ORIGINATION FORM

Proposed Revisions to a Standard Plans Index
(Please provide all information – Incomplete forms will be returned)

Index Number: 700-041
Sheet Number (s): 1, 2, &4
Index Title: Span Sign Structure

Summary of the changes:

LAST REVISION 11/01/18	DESCRIPTION: 11/01/19	 FY 2019-20 STANDARD PLANS	SPAN SIGN STRUCTURE	INDEX 700-041	SHEET 1 of 5
----------------------------------	---------------------------------	---	---------------------	------------------	-----------------

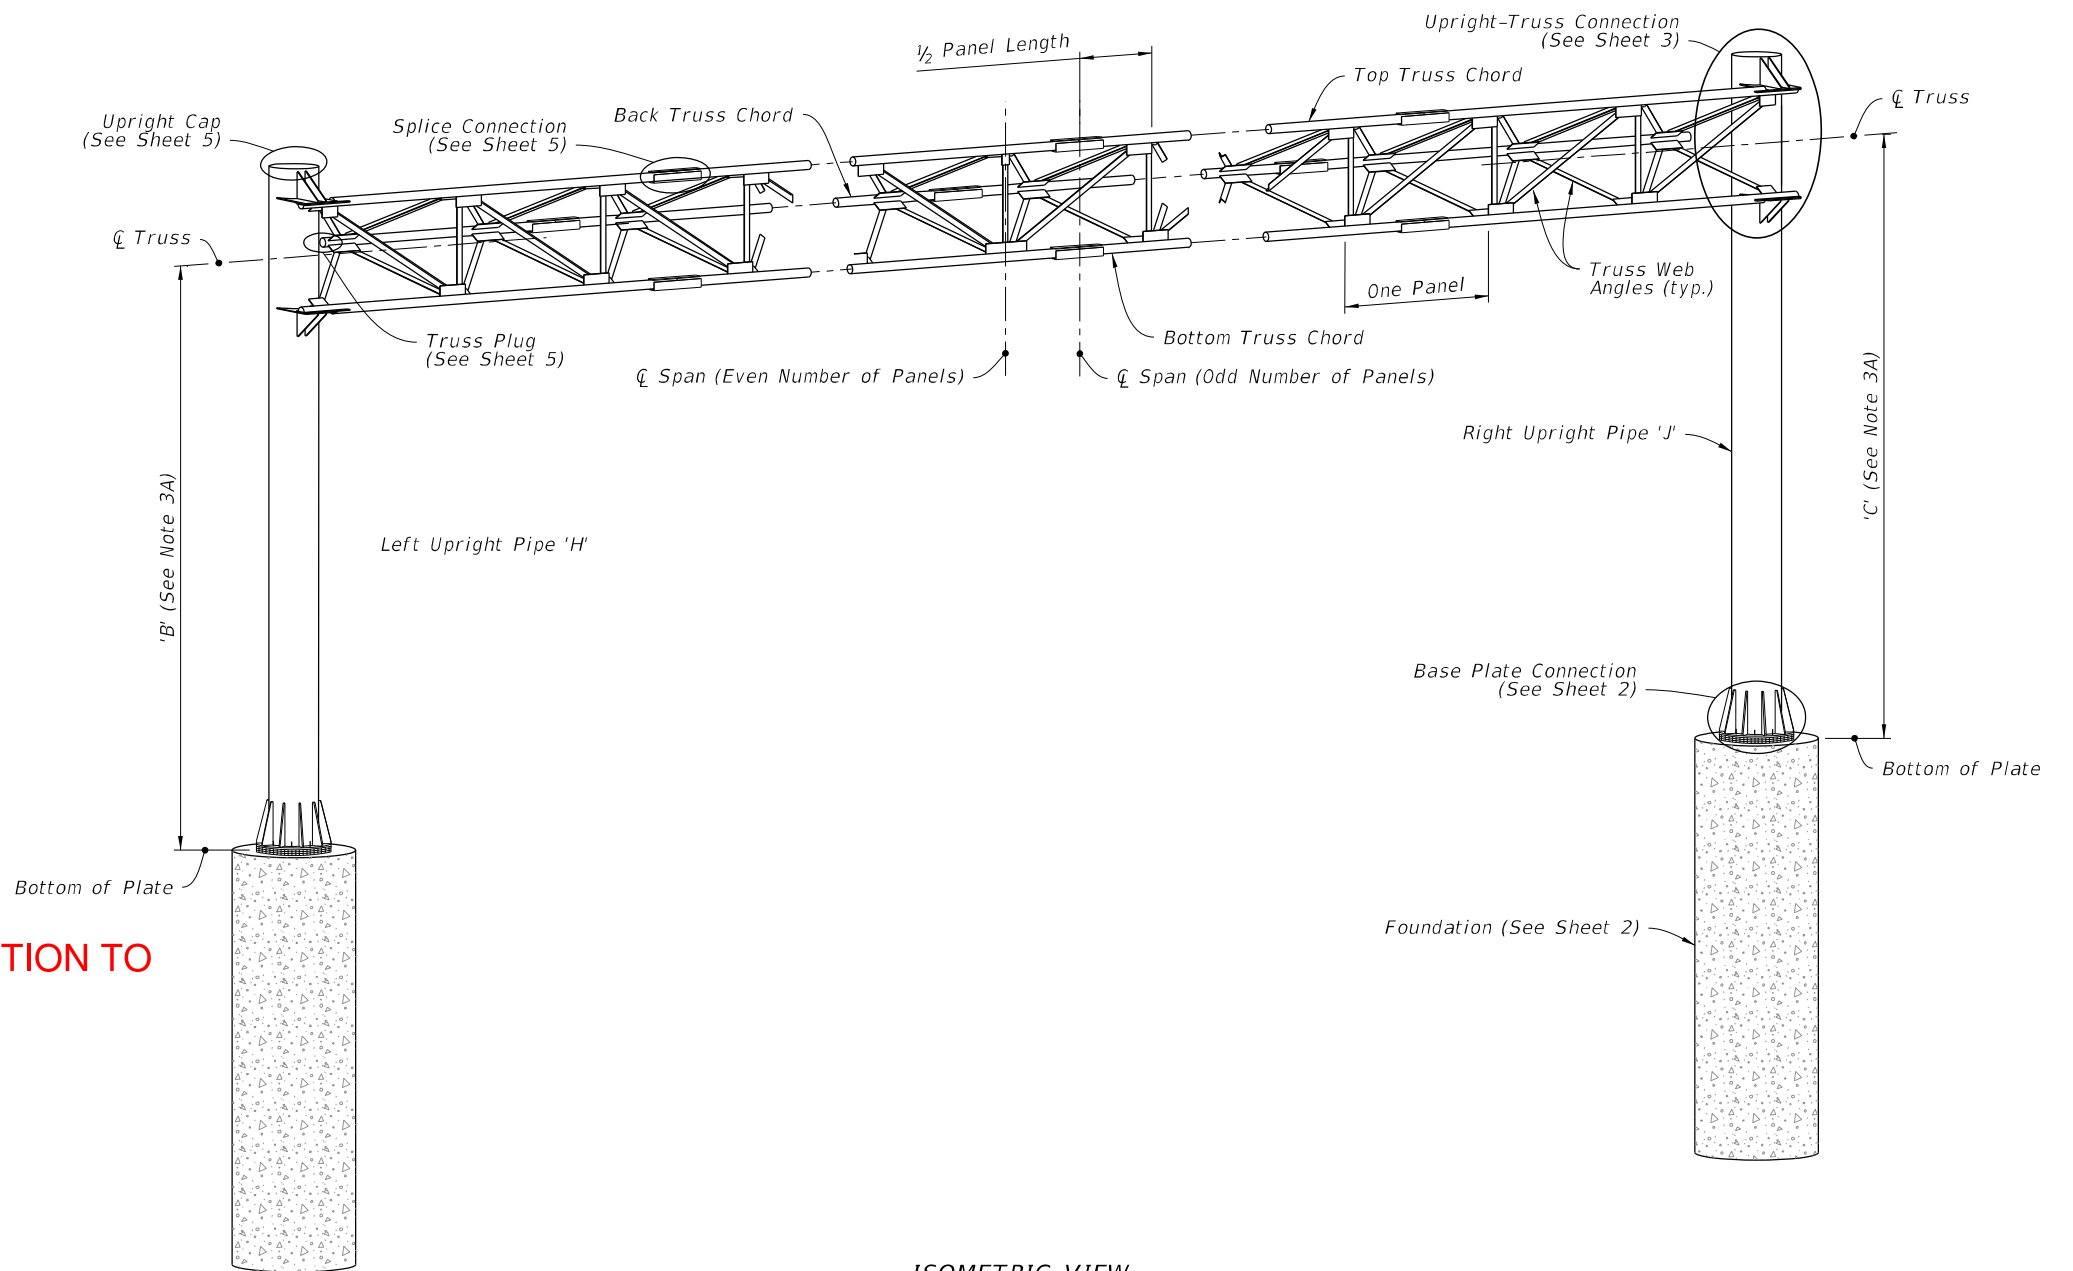
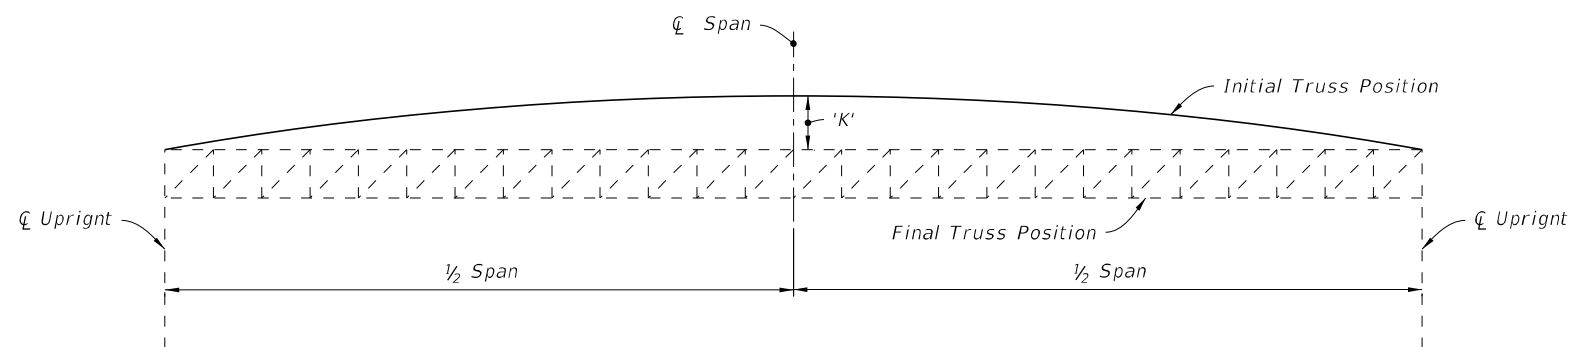
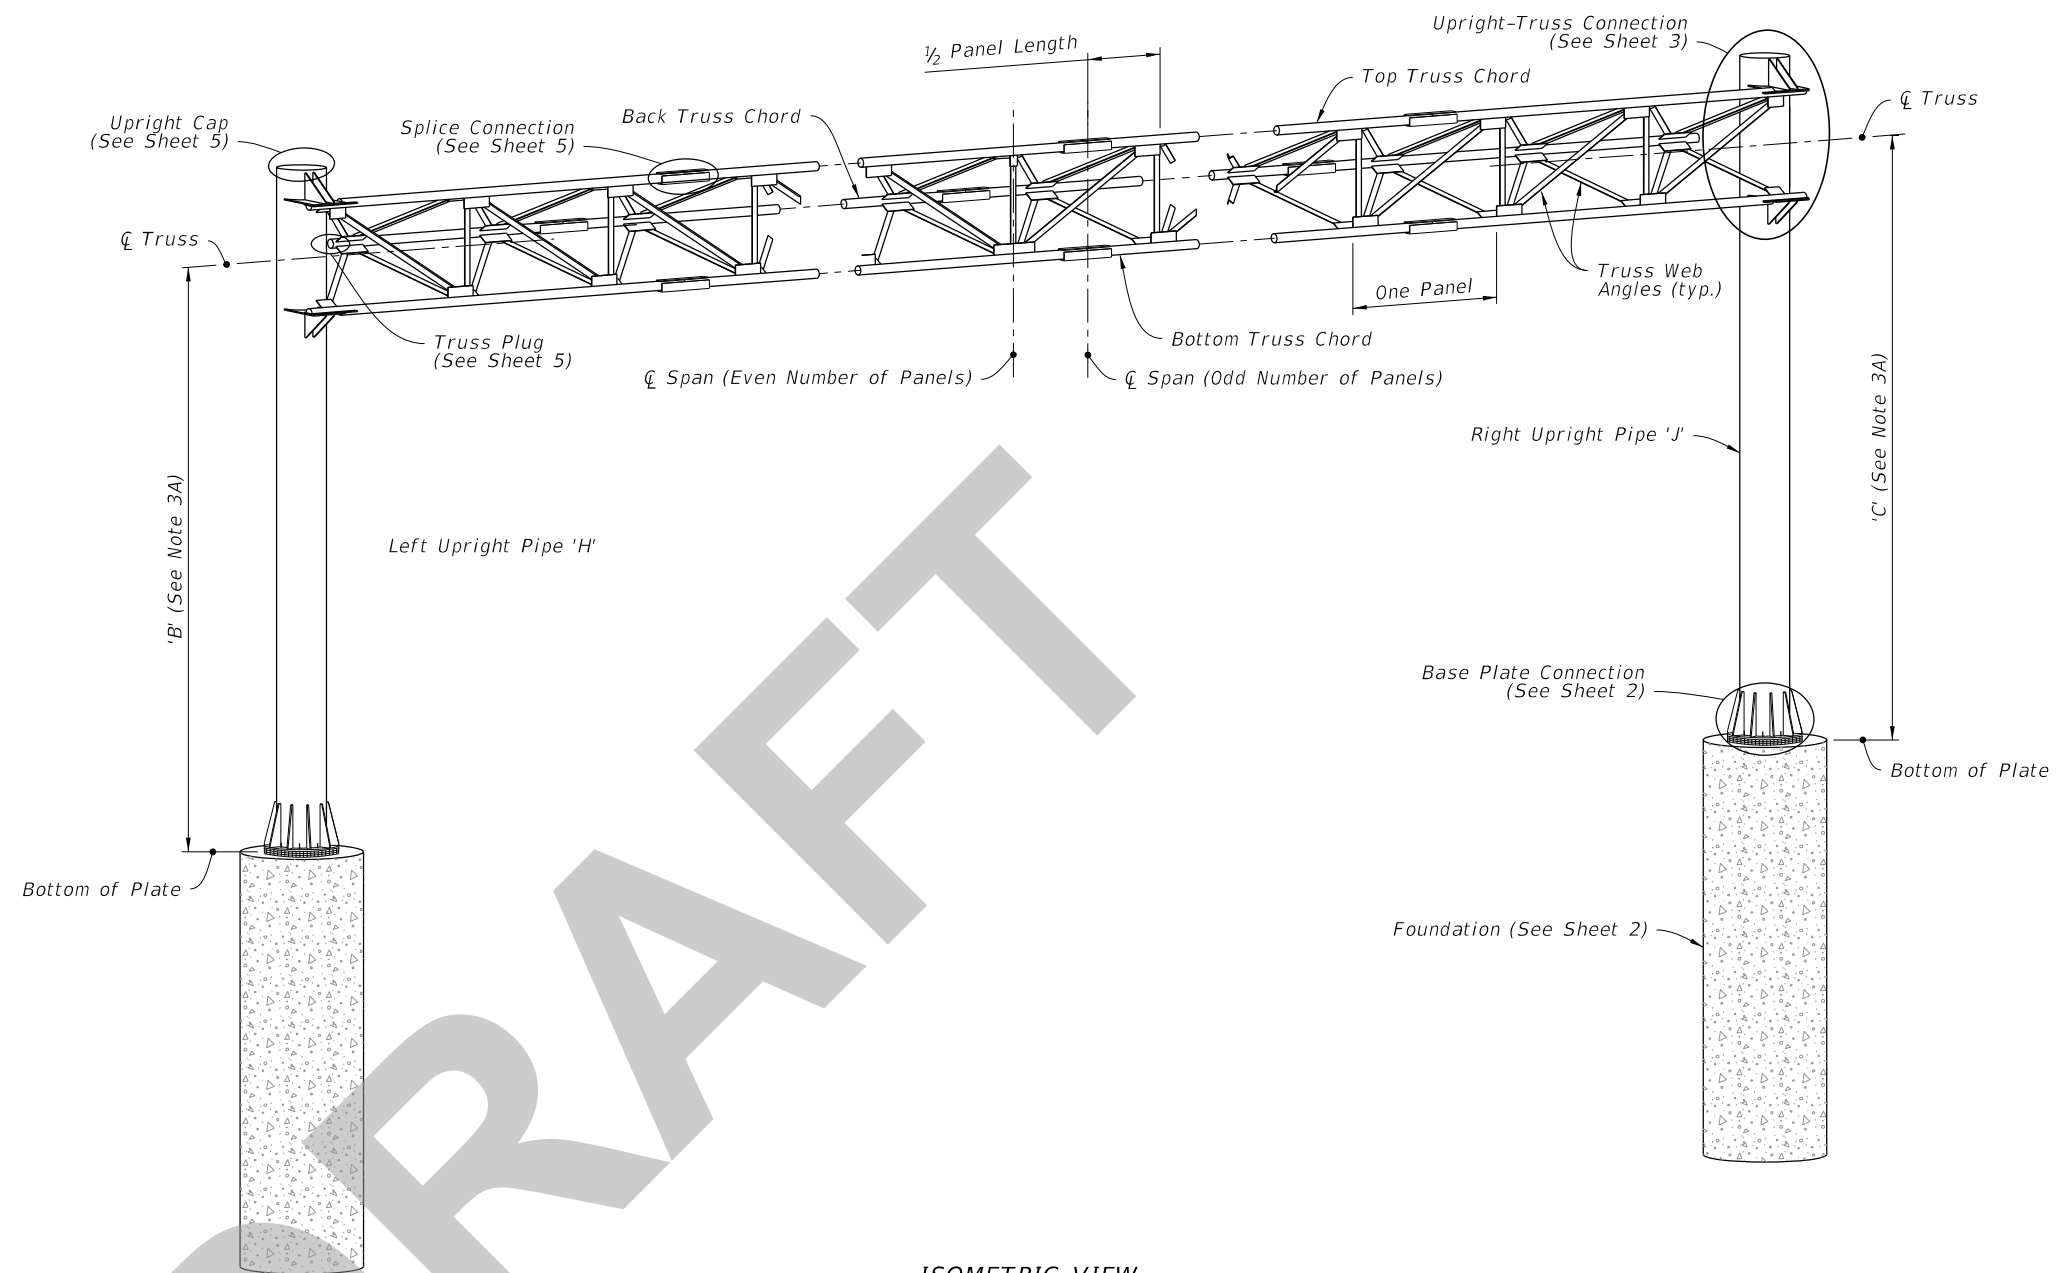
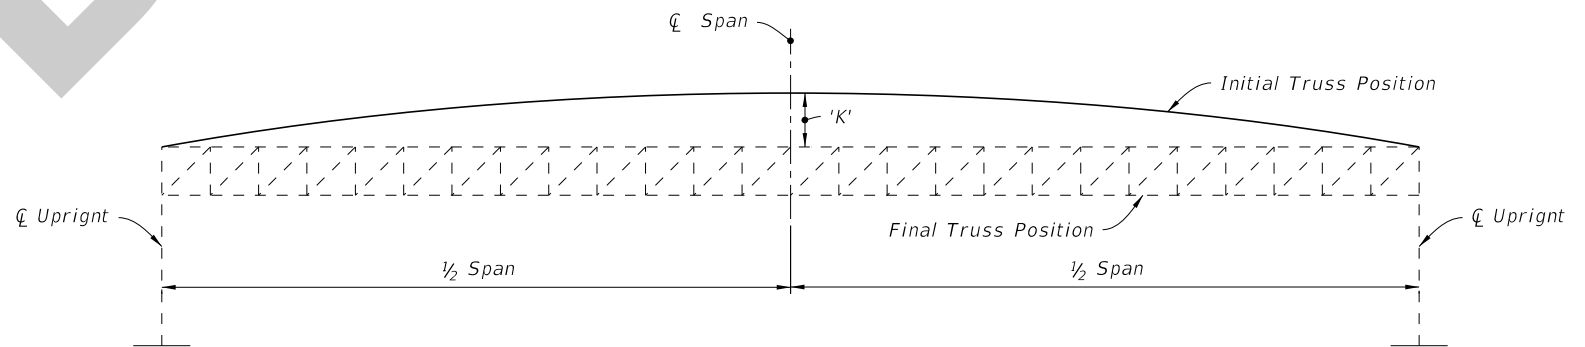
Added paragraph and bullets pertaining to shop drawing review.

Add notes for shop drawing review listing possible fabrication restrictions to meeting notes 5B and 5C on the Std Drawings.

- A. Welding: Specification 460-6.4
- B. Chord Splices: Minimum splice spacing is three truss panel lengths apart and three truss panel lengths from the uprights when panel lengths are 10'-0" or less. Chord Splices may be either the Standard Splice or the Alternate Splice, but not both on the same structure.
- C. Upright splice: Not allowed unless the upright exceeds available mill lengths (35' - 40').
- D. Structural bolt hole diameters: Bolt diameter plus 1/16".
- E. Anchor bolt hole diameters: Bolt diameter plus 1/2".
- F. Hot Dip Galvanize after fabrication.
- G. Shop assemble the entire structure after galvanizing to validate/document alignment and clearance for bolted connections as well as contact between connecting plates. Take remedial action, if necessary, prior to shipment.
- H. Disassemble as necessary and secure components for shipment.
